CITY OF AUSTIN – TRAVIS COUNTY – SINGLE SUBDIVISION OFFICE
SUBDIVISION APPLICATION – MASTER COMMENT REPORT

CASE NUMBER: C8J-2019-0186PA
REVISION #: 00
CASE MANAGER: Joe Arriaga
UPDATE: U2
PHONE #: 512-854-7562

PROJECT NAME: Premier Logistics Park Project Assessment
LOCATION: 2900-1/2 FERGUSON LN

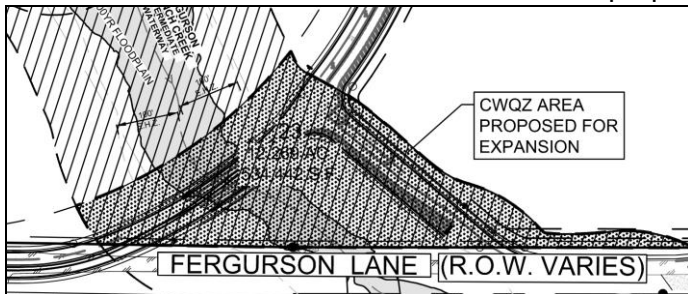
Update 2 Thank you for the exhibit, sh. 9. When you submit the permit application, add a note explaining why the hatched area below is included in the ROW.

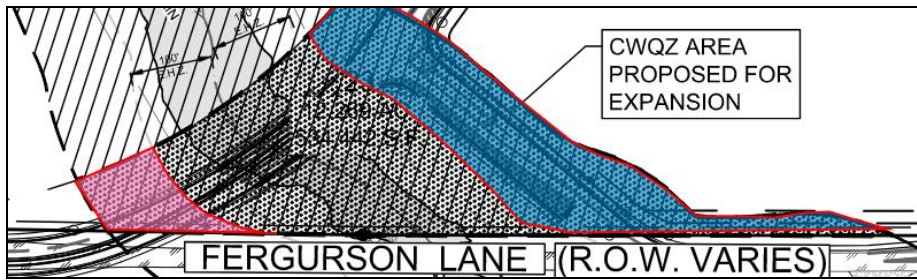
- 1) Correct the callout below to read "CWQZ area proposed for *reduction*."

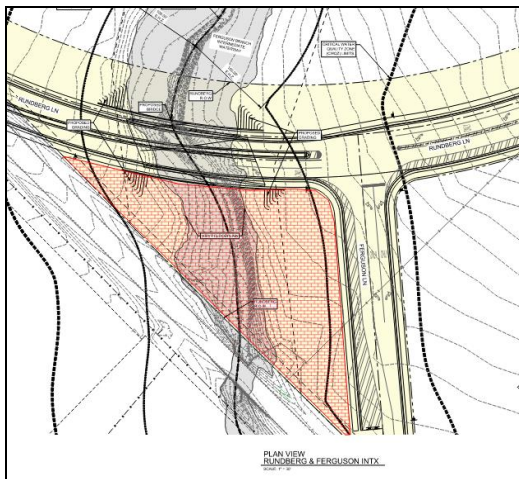
- 2) The original EV 1 comment states, "Use Buffer Averaging to reduce the CWQZ to 100 feet from the centerline on the east side of Ferguson Branch Creek at that location." The blue shading below shows the 100-foot decrease in the buffer width that I had in mind. The same can be done on the west side of the waterway (pink shading), which would allow grading for the ROW on either side of the waterway, outside of the minimum 200 feet of buffer.

On the second submittal (U1), I missed the fact that the reduction had gone beyond the 100-foot limit. My apologies.

Per LDC 25-8-92 - CRITICAL WATER QUALITY ZONES ESTABLISHED.

(B) In the suburban watersheds ...

(4) the critical water quality zone boundaries may be reduced to not less than ... 100 feet from the centerline of an intermediate waterway, ... if the overall surface area of the critical water quality zone is the same or greater than the surface area that would be provided without the reduction, as prescribed in the Environmental Criteria Manual.
